ADDENDUM #4

Citrus Grove Road Phase 2
Project No. 2025-04, Bid No. 25-749

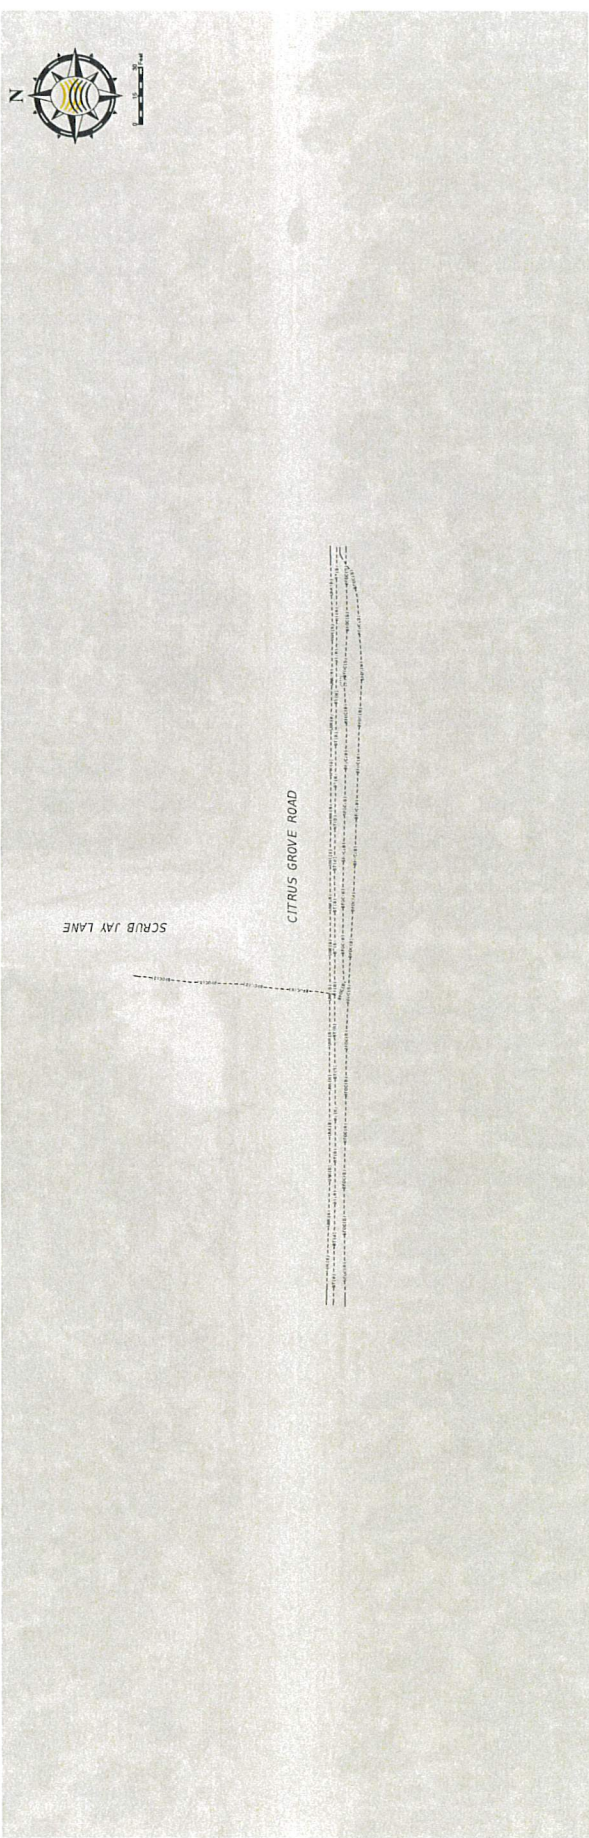
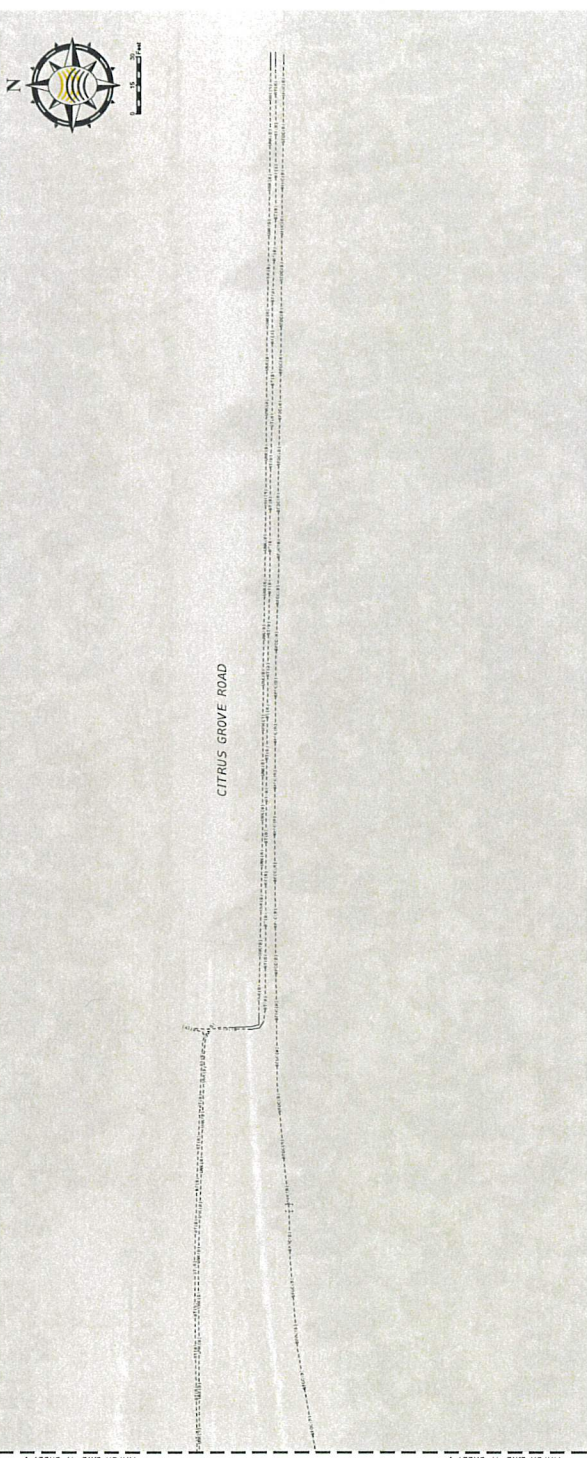
Q3: Utility adjustment Sheet 9, Plan Sheet 121, at approx.. Sta. 1042+20 Right, there's a note stating "unknown buried utilities to be adjusted horizontally by contractor"? That's pretty hard for us to bid and figure what might be need with "unknown" utility. Please provide more information.

A3: The utility surveyor found several buried utilities in the area. We were unable to determine the owner of these utilities and none of the utility companies claimed ownership. The VVH test holes performed for the signal pole on the SE corner located two conflicting underground conduits. The VVH information on each of these unknown utilities collected in the field is shown in the table on Sheet 121 and shows that the conflicting utilities are 1.75" to 2" diameter polyethylene pipes. These pipes are in conflict with the proposed signal mast arm foundation and will need to be relocated prior to the installation of the drilled shaft. To provide all available test hole information, please find included the full Test Hole Data Report for both mast arm locations at the Grassy Lake Road intersection.

LAKE COUNTY		DEPARTMENT OF PUBLIC WORKS		SHEET NO.	
ROAD	CITRUS GROVE	COUNTY	LAKE	---	
FINANCIAL PROJECT ID		ALTERNATIVE ACCESS EXHIBIT

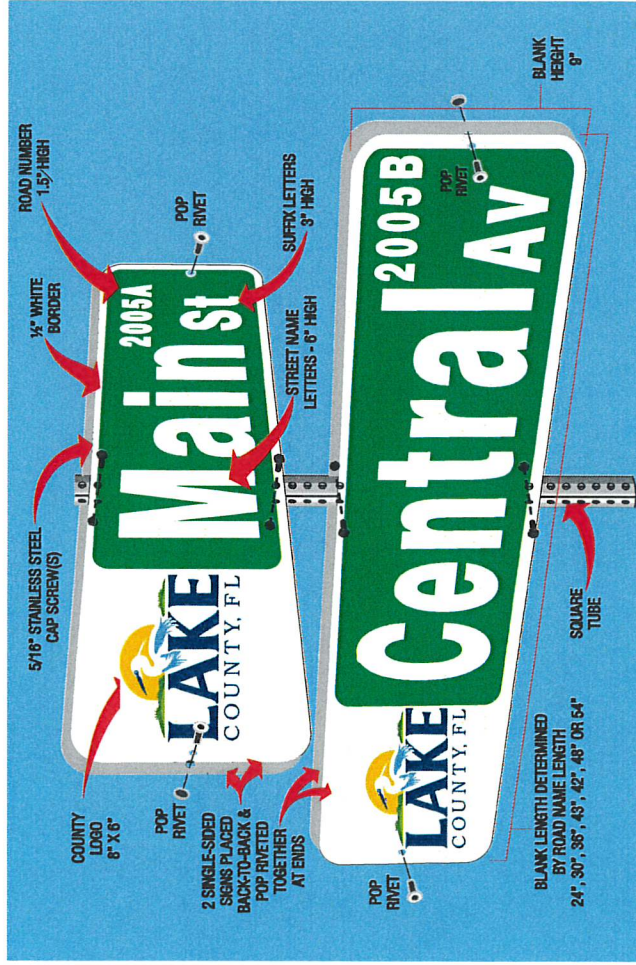
Please see the attached map for placement of additional fill dirt if needed.
